No. EC120-25A031

ALERT SERVICE BULLETIN

**EQUIPMENT AND FURNISHINGS - Emergency Floatation Gear
New Emergency Floatation System (EFS) "FLOAT ARM"
push-button location**

Revision No.	Date of issue
Revision 0	2023-10-25

Figure 1

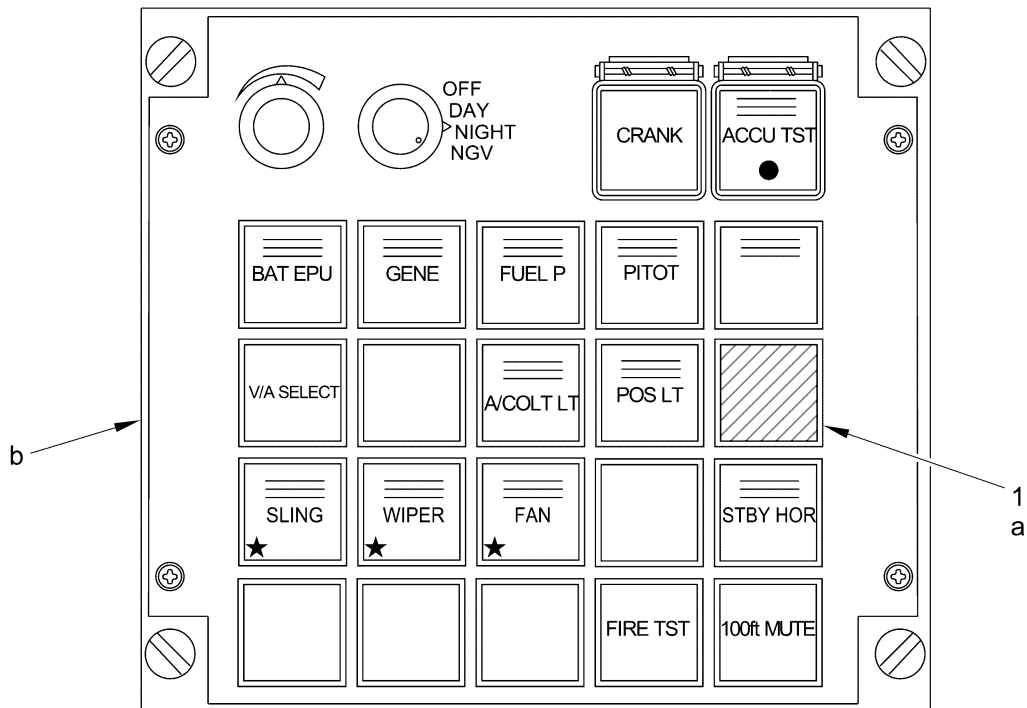
3.B.2.a. Removal of the EFS "FLOAT ARM" push-button - **ALL CONFIGURATIONS** ([Figure 1](#))

- Remove the EFS "FLOAT ARM" push-button (a) from the control unit (b) (Detail A). Refer to Task 31-42-00, 8-2 (AMM).
- Discard the EFS "FLOAT ARM" push-button (a).

- Clean the printed circuit board of the LACU. Refer to Task 31-42-00,7-1 (AMM).
- Install the obturator (1) on the control unit (b). Refer to Task 31-42-00, 8-2 (AMM).
- Make sure that all the push-buttons are correctly positioned.

Figure 2

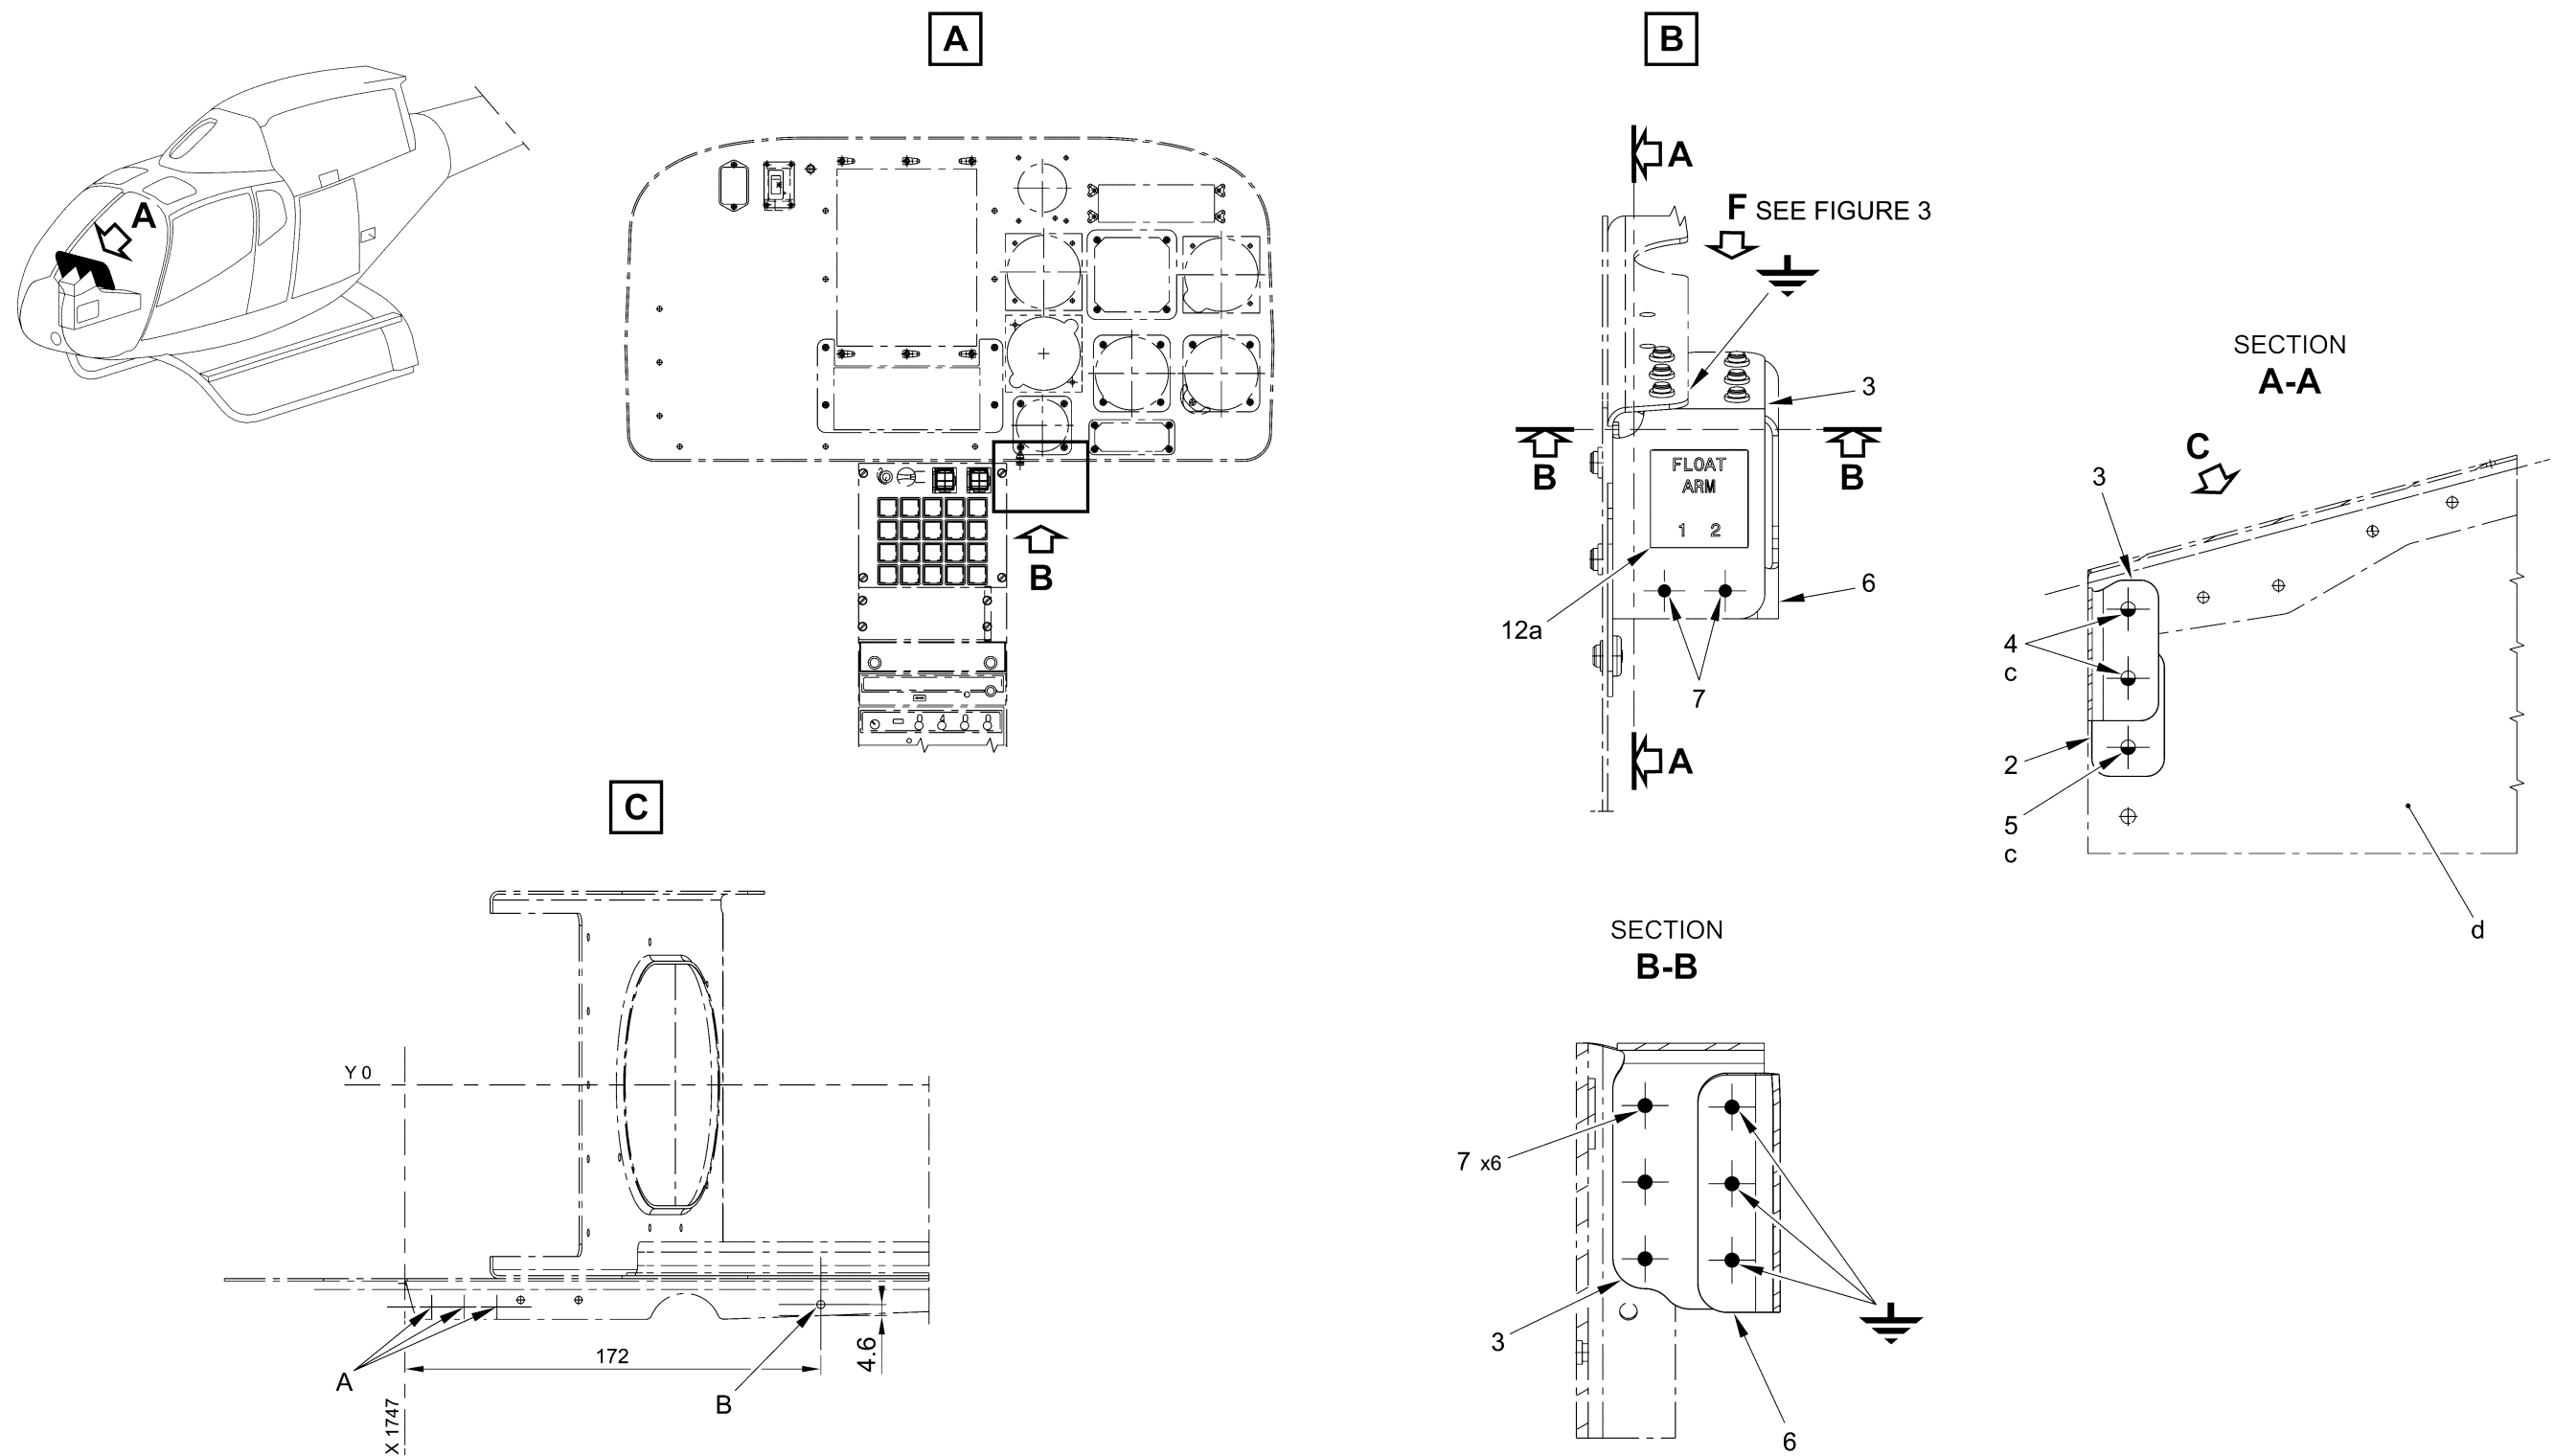
3.B.2.b.1. Modification of the push-button location under the instrument panel - **CONFIGURATION 1** ([Figure 2](#) and [Figure 3](#))

- Remove the rivets (c) ([Figure 2](#), SECTION A-A).
- Put in position the shim (2) and the bracket (3).
- Counter-drill the holes (A) to match with the bracket (3) to a diameter of 2.6 mm ([Figure 2](#), Detail C).
- Drill the hole (B) in accordance with the dimensions to a diameter of 3.3 mm.
- Drill the holes (C) in accordance with the dimensions to a diameter of 3.3 mm ([Figure 3](#), Detail D).

- Deburr the holes (A), (B) and (C) and clean the work area.
- Install the shim (2) with the rivets (5) ([Figure 2](#), SECTION A-A).
- Install the bracket (3) with the rivets (4).
- Install the cover (6) on the bracket (3) with the rivets (7) (Detail B and SECTION B-B).
- Bond the label "20GR" from the set of wires and labels (11) inside the bracket (3) (not shown).
- Install the push-button (12a) of the ramp (12) on the bracket (3) ([Figure 2](#), Detail B).
- Install the support (8) ([Figure 3](#), Detail E) and the clamp bracket (9) (Detail F) with the rivets (10).
- Do the electrical bonding on the bonding areas.

3.B.2.b.2. Modification of the push-button location under the instrument panel - **CONFIGURATION 2** ([Figure 2](#), [Figure 3](#) and [Figure 7](#))

- Do the electrical bonding of the holes of the rivets (10), (22) and (23).
- Install the LH stiffener (19) and the reinforcement angle (21) with the rivets (10), (22) and (23).
- Put in position the shim (2) and the bracket (3) ([Figure 2](#), SECTION A-A).
- Counter-drill the holes (A) to match with the bracket (3) to a diameter of 2.6 mm ([Figure 2](#), Detail C).
- Drill the hole (B) in accordance with the dimensions to a diameter of 3.3 mm.
- Drill the holes (C) in accordance with the dimensions to a diameter of 3.3 mm ([Figure 3](#), Detail D).

- Deburr the holes (A), (B) and (C) and clean the work area.
- Install the shim (2) with the rivets (5) ([Figure 2](#), SECTION A-A).
- Install the bracket (3) with the rivets (4).
- Install the cover (6) on the bracket (3) with the rivets (7) (Detail B and SECTION B-B).
- Bond the label "20GR" from the set of wires and labels (11) inside the bracket (3) (not shown).
- Install the push-button (12a) of the ramp (12) on the bracket (3) ([Figure 2](#), Detail B).
- Install the support (8) ([Figure 3](#), Detail E) and the clamp bracket (9) (Detail F) with the rivets (10).
- Do the electrical bonding on the bonding areas.

Figure 3

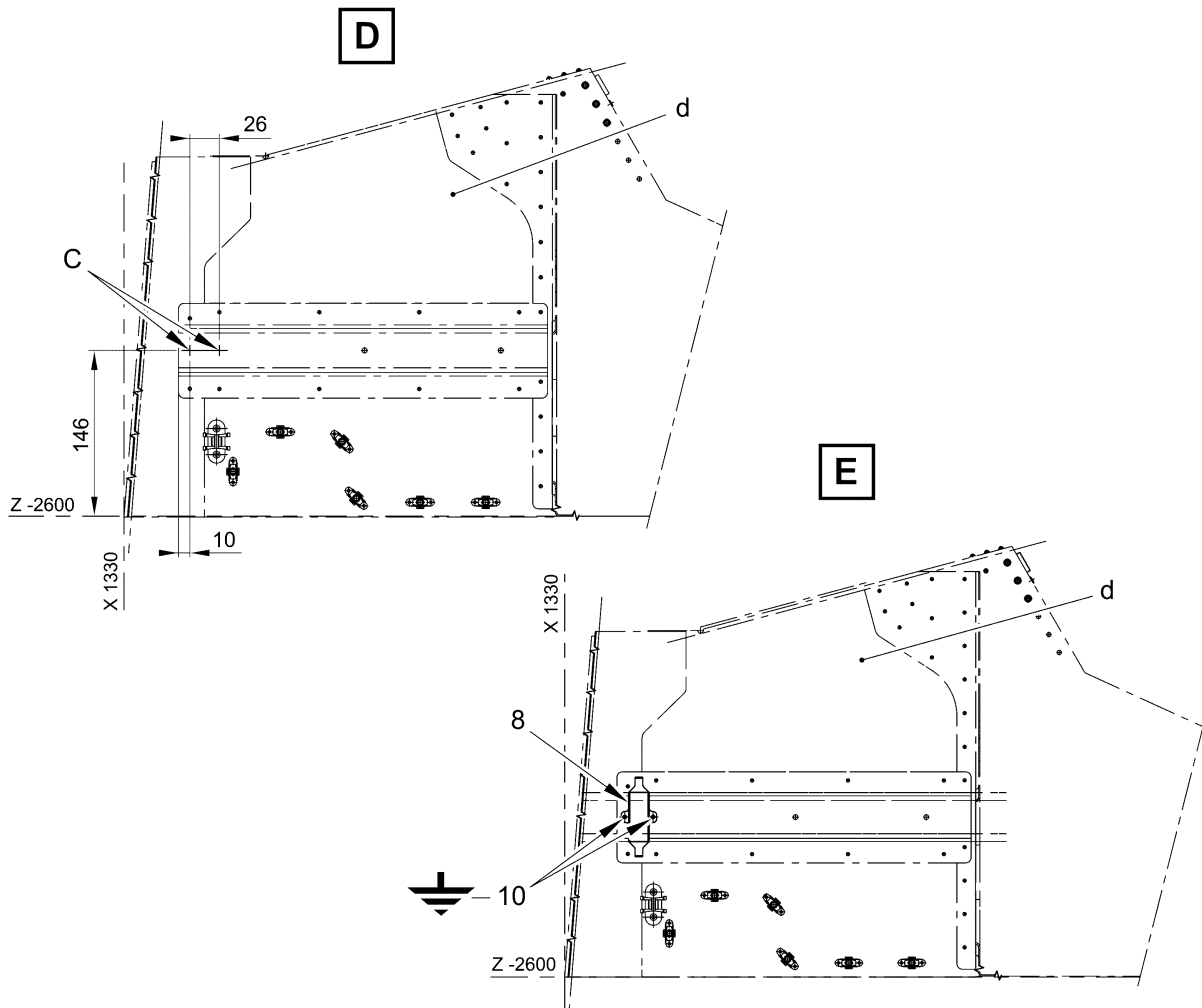
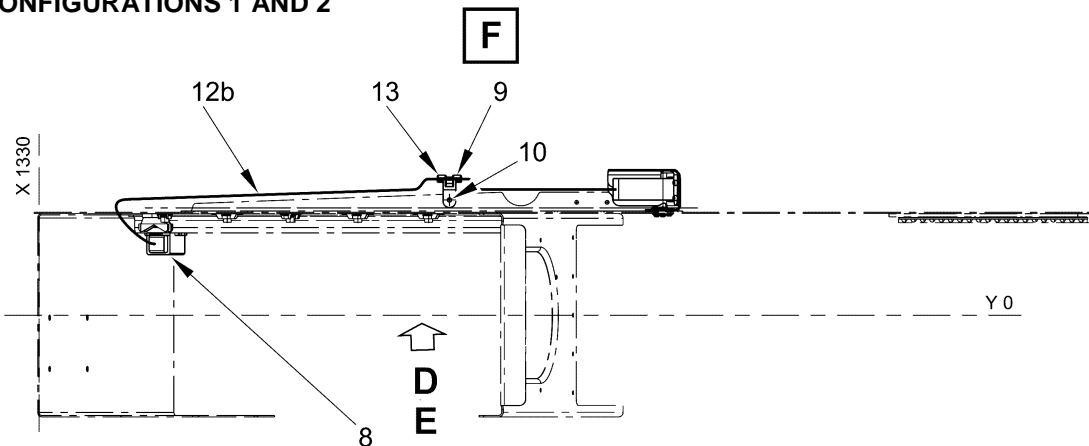
- Do the cut-out (D) and deburr in accordance with the dimensions ([Figure 6](#), Detail B).
- Install the push-button (12a) of the ramp (12) on the instrument panel (f).
- Bond the label "20GR" from the set of wires and labels (11) as near as possible to the push-button (12a) on the back of the instrument panel (f) (not shown).
- Drill the holes (C) in accordance with the dimensions to a diameter of 3.3 mm ([Figure 3](#), Detail D).
- Deburr the holes (C) and clean the work area.

- Install the support (8) ([Figure 3](#), Detail E) and the clamp bracket (9) (Detail F) with the rivets (10).
- Do the electrical bonding on the bonding areas.

- Route the wire (12b) from the support (8) through the clamp bracket (9) with the clamps (13) ([Figure 3](#), Detail F).

Figure 4

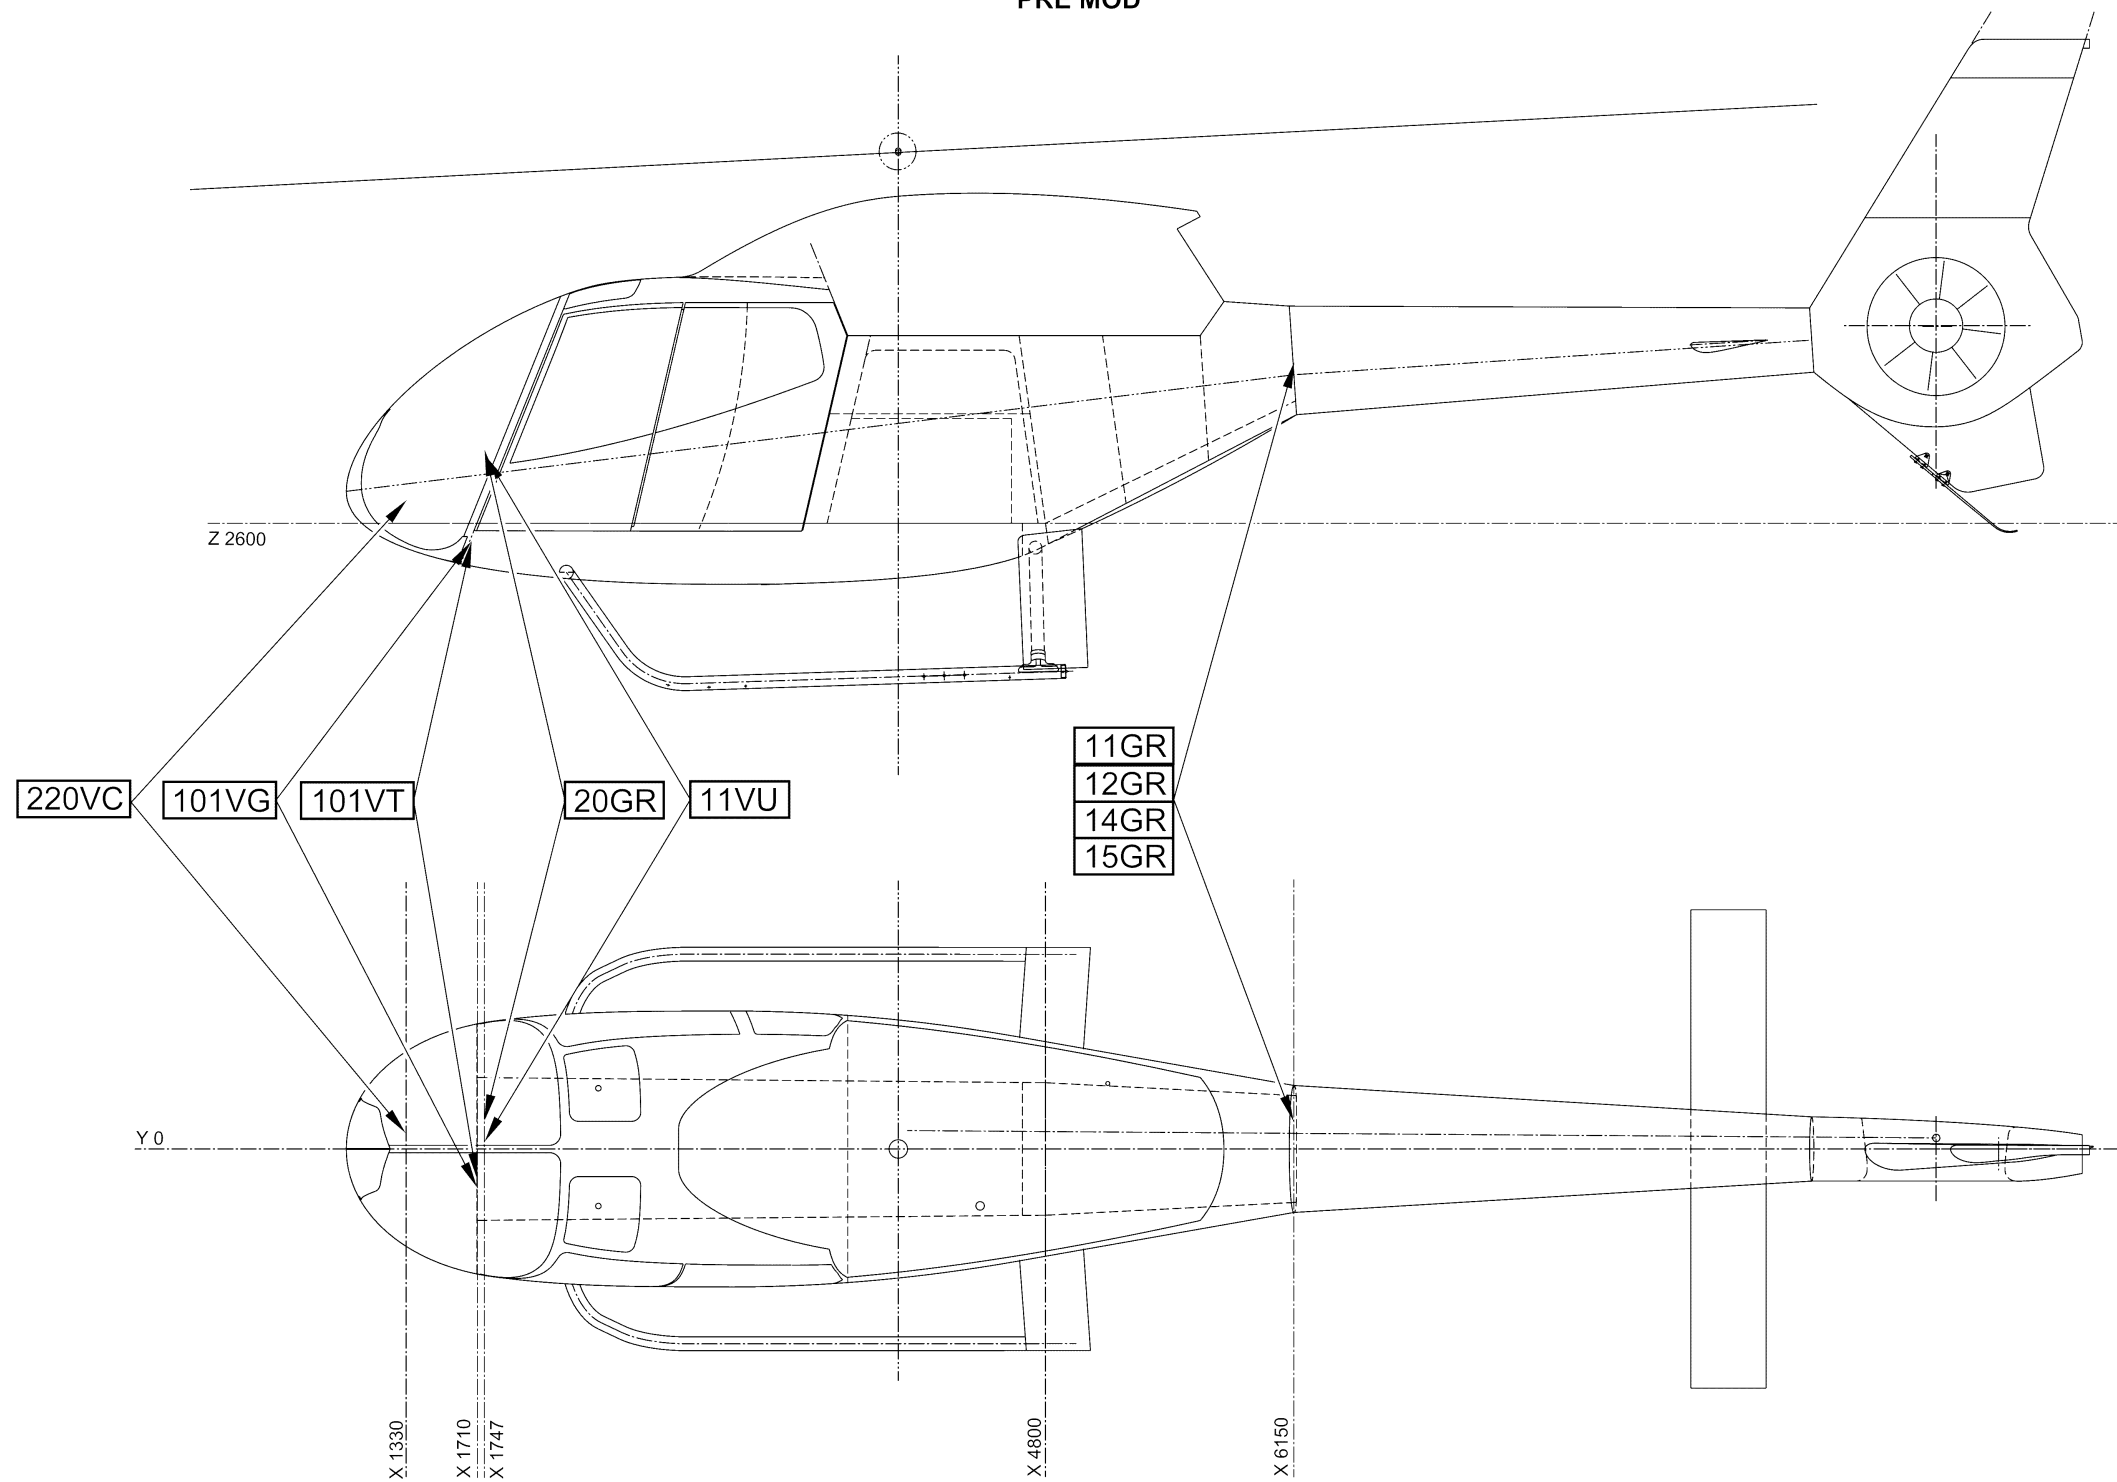
3.B.2.c. Modification of the electrical wiring ([Figure 3](#), [Figure 4](#) and [Figure 5](#))

- Cut to the required length and connect the wire (12b) with ([Figure 4](#) and [Figure 5](#)):
 - . The contacts (14)
 - . The module (15).
- Modify the electrical wiring with:
 - . The wires "2567-0109", "2567-0092", "2567-0093" and "2567-0090" from the set of wires and labels (11)
 - . The contacts (16) and (17)
 - . The module (18).
- Do a continuity test on the installed wires.
